Final Environmental Impact Report
Stadium Center Phase III Project

SCH# 2007012018

Prepared for:
City of Manteca

March 2008

**Exhibit DOT-1
Traffic Analysis Zone Map of SJCOG Model**

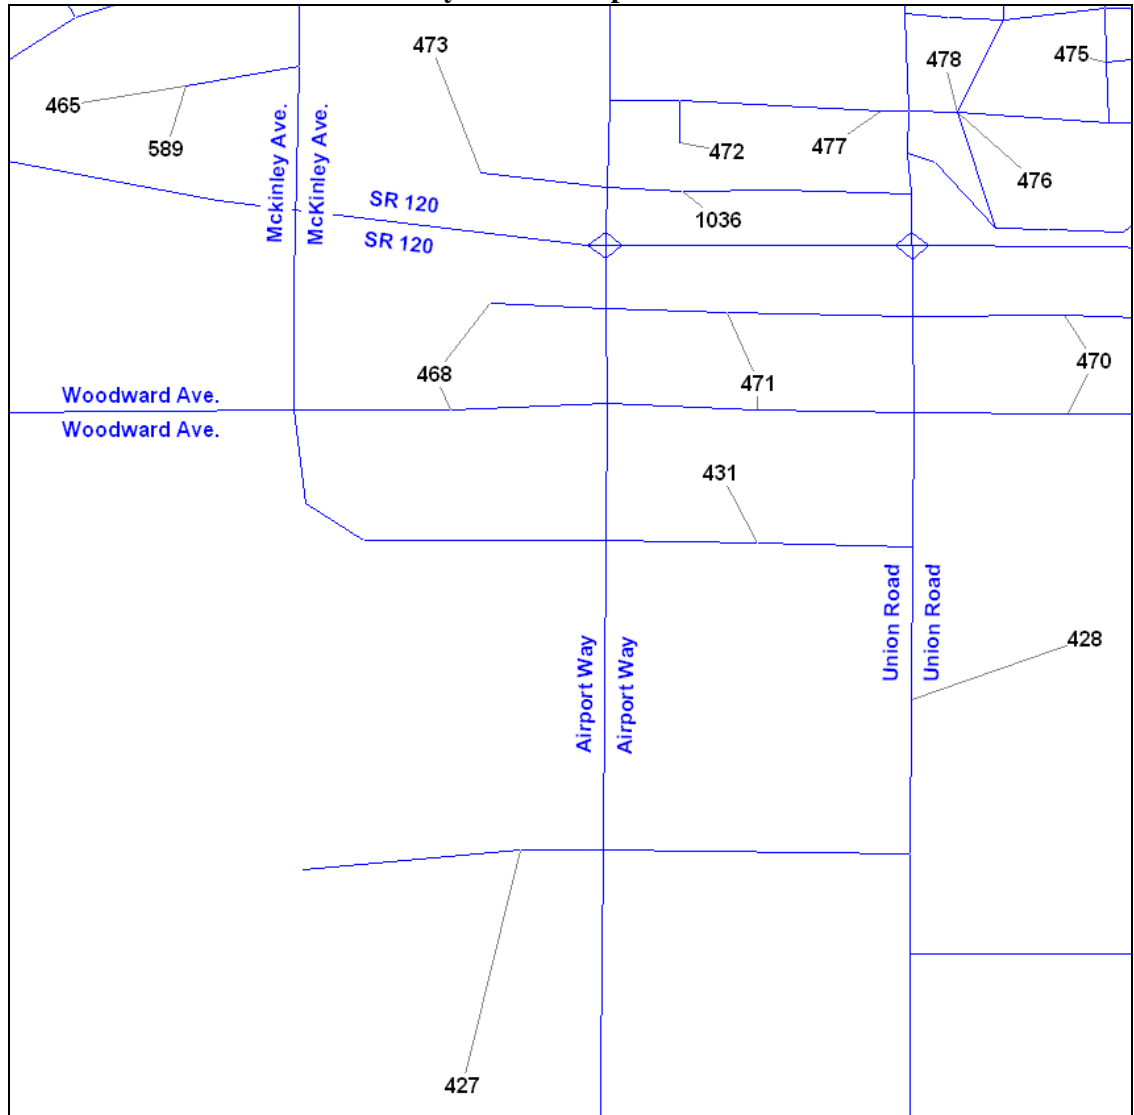
SJCOG model traffic forecast for the SJ-120/Airport Interchange does not account for the City's increased level of build-out, then the assumption that the future interchange project will provide the mitigation for the development's traffic will not be valid.

The version of the SJCOG model used in the Draft EIR to analyze traffic impacts associated with the Stadium Center III project was updated with information provided by the City related to buildout of land uses to generate representative traffic forecasts for the study area. The land uses in the original SJCOG model were replaced with updated land uses created in collaboration with City of Manteca planning staff based on on-going traffic improvements and projected development within the City of Manteca. Table DOT-1 below presents a comparison of the land use forecasts in the original SJCOG model and the updated land use forecasts generated in consultation with the City. Along with this, Exhibit DOT-1 below shows the location of the traffic analysis zones.

As shown in Table DOT-1, the updated SJCOG model used in the analysis projects substantially more households and employees as compared to the original SJCOG model. In cases where there is less development in the updated model, the reduction was caused by a manual shift in development from one zone to another to ensure more accurate loading of trips to the local street network. For example, Zone 1036 (see Exhibit DOT-1) was used to represent the Stadium Center III and adjacent Manteca Retail Center projects. Because no homes exist or are proposed in these retail projects, the number of households was set to zero and the surrounding residential zones were checked to ensure that they represented the appropriate number of residential dwelling units. Therefore, the traffic modeling analysis

provided in the Draft EIR is sufficiently representative of projected buildout traffic conditions based upon the best available information provided by the City of Manteca.

FIGURE 11-10A

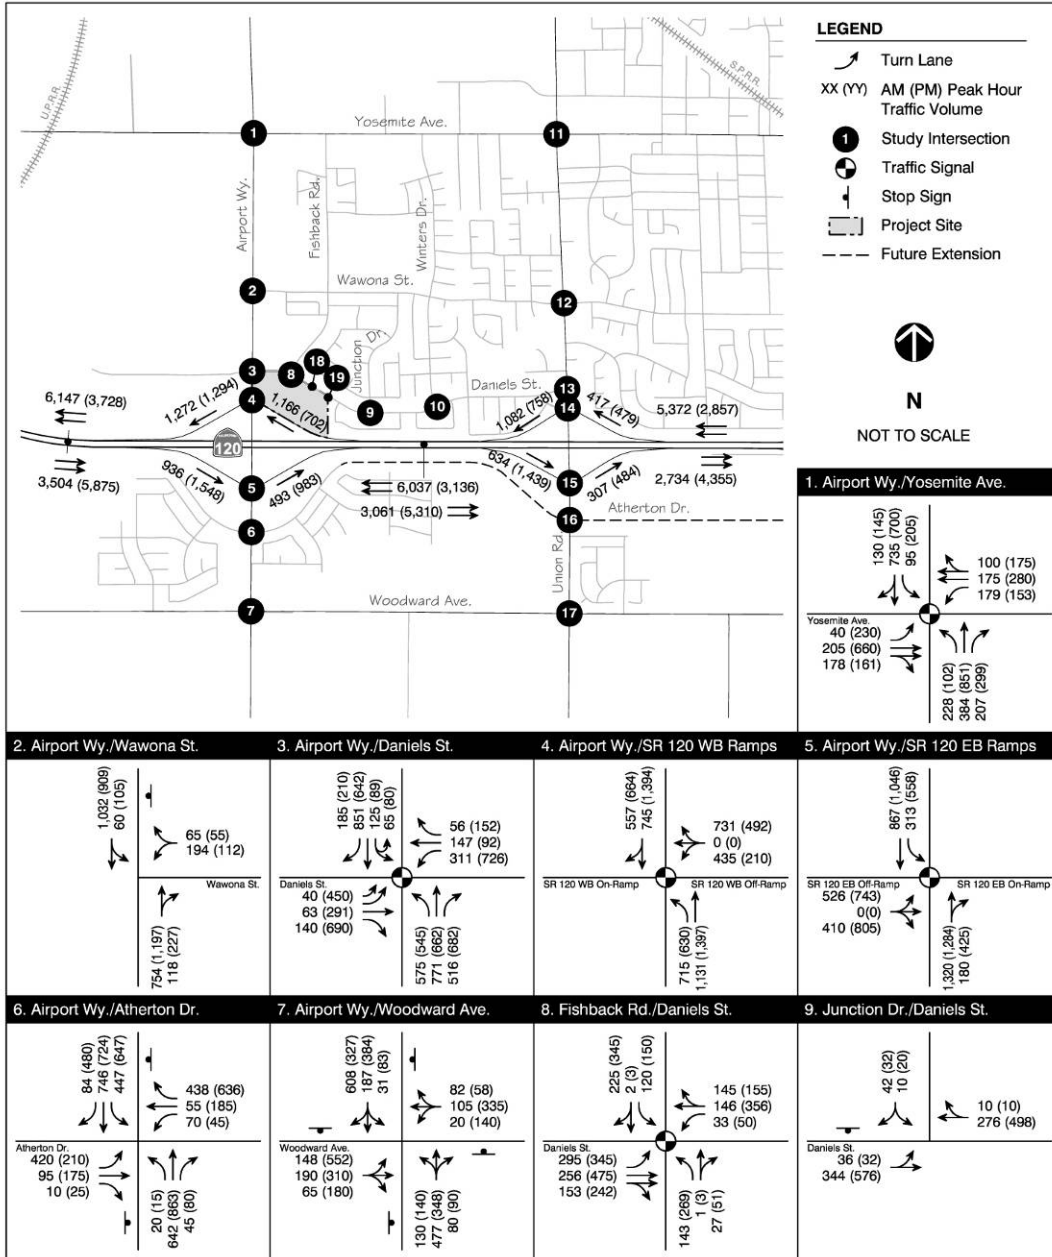
- Figure 11-10A lane configurations cumulative plus project conditions for EB & WB is not correct, it needs to match the condition of the opening date. If the interim mitigation is the signal project the "existing + project" condition needs to analyze and document this condition. The TIS currently shows STOP Control at the ramps.

- DOT-4** The lane configurations have been corrected and the Draft EIR analysis updated. However, the results presented in Table 4.11-13 of the Draft EIR would not change because the delay at the Airport Way/SR 120 ramp terminal intersections would continue to exceed 100 seconds even with the signalization improvements. An updated Figure 4.11-10a and technical calculations are identified in Chapter 3, “Revisions to the Draft EIR” of this Final EIR.

PAGE 14 OF APPENDIX E, FIGURE 11-10A IS HEREBY REPLACED WITH THE FOLLOWING:
